# Board of Adjustment STAFF REPORT

**MEETING DATE:** October 11, 2016

1. **DSA-16-00087: Variance request** to Sign Regulations applicable to the R-3 (Multi-Family Residential) zone district to allow:
  - a. A 12 sq. ft. low-profile sign, that is to be *perpendicular* to Peart Rd. where if low profile, a sign shall be *parallel* to the street per Section 603.3.B of City Sign Code.
  - b. Same low-profile sign to be entirely within public right of way (14.97 ft. from curb), where sign shall be placed a minimum of 20 ft. inward from front property line per Section 603.3.B. per City Sign Code.

Exhibit A – Sign details

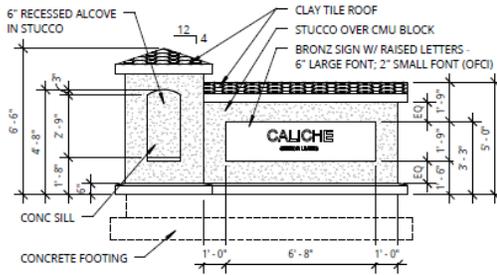
When the applicant began to erect a 6.5 ft. tall low-profile sign, 11.66 sq. ft. in area to display the name "Caliche Senior Living" (Exhibit A), staff reminded the applicant that signage is required by permit and where it's being placed is in conflict with the R-3 sign standards. Though the sign area and height complies with the City Sign Code, the sign's orientation and placement does not meet R-3 signage standards. The sign is perpendicular to the street, where the code states it is to be parallel. Also, the sign sits entirely within Peart Rd. right of way. Though signage can be permitted to be within the right of way with the consideration of an right of way encroachment permit; the requirement for the R-3 is that the sign is to be setback a minimum of 20 ft. from the front property line so as not to project into the property's "front yard setback" (Exhibit B).

Though the structure being constructed is 12 ft. X 6.5 ft., per Exhibit A, the area of sign is considered as consisting of only 11.66 sq. ft., meeting the 12 sq. ft. area limitation. This is based on the definition of "Area of Sign" in the City Sign Code. The location which the copy is placed is recessed and distinguished from the rest of the structure, resulting in the structure for the sign to not be counted towards the sign area.

- 1. Provide the location of and identify the front property line, parallel to Peart Rd on the site plan sign location typical.
- 2. Provide additional dimensions: The length of the sign (beyond the 4.06 ft. endcap), and the distance between the sign and the property line.
- 3. Revise corner visibility triangle on the site plan sign location typical to reflect the one, found in City Code section 17.52.450 and 17.52.160(C) which can be interpreted to show a distance 15 ft. in each direction from the center point of the driveway along the projected curb line, then ten feet back toward property then at an angle back to the point of beginning.

Exhibit B – ROW Site Plan

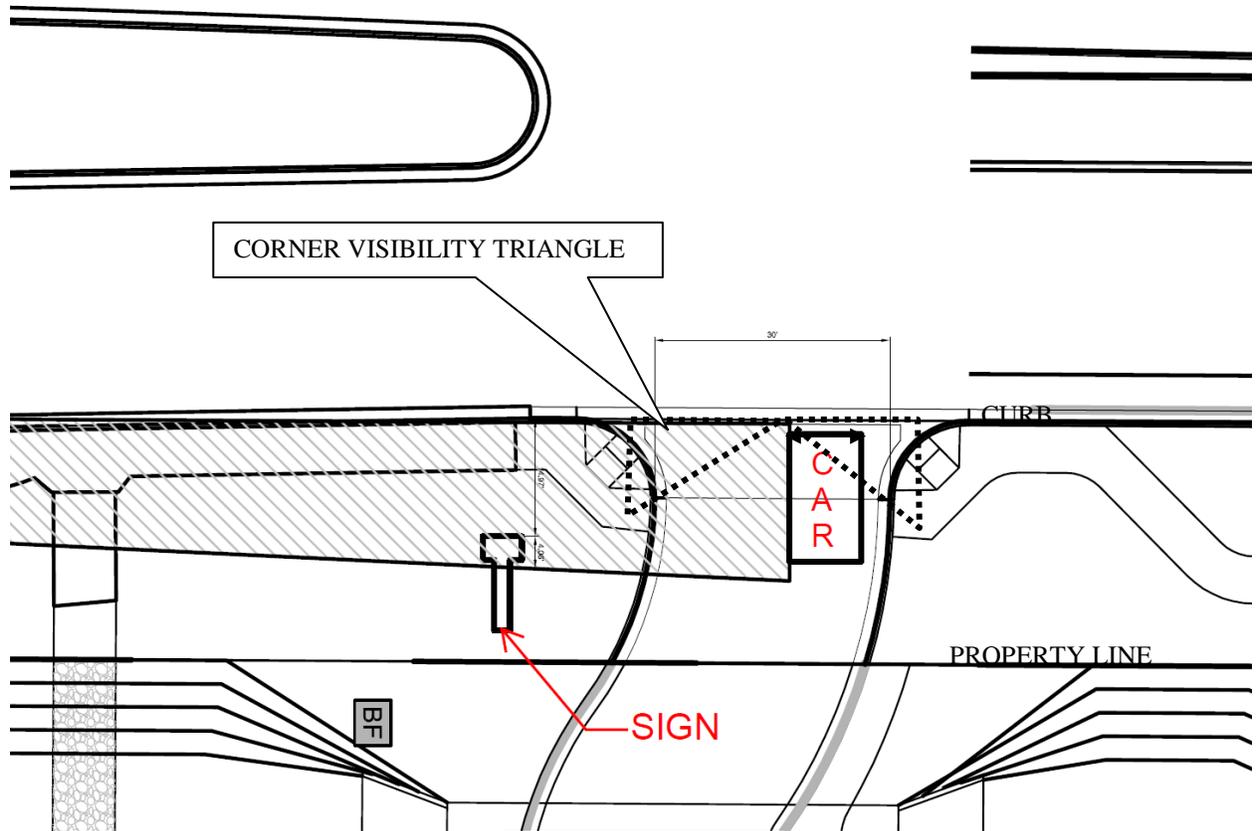
Staff can support the sign being within the right of way with the issuance of a right of way encroachment permit. The applicant has submitted a permit and is awaiting approval, contingent upon the Board of Adjustment's consideration of the variance. Signs placed in the right of way should not impede with future road improvements, nor should it block visibility of oncoming pedestrians and vehicles. The sign is located in an area that will be out of the way from any future lane expansion. City Code section 17.52.160.C. states that at the intersection of each driveway with a street, a triangular area where corners are defined by two points on the right –of-way line, fifteen feet on each side of the centerline of the driveway and a point on the centerline ten feet outside of the right of way must be clear of unobstructed. The proposed sign placement is outside of this triangular visibility area.
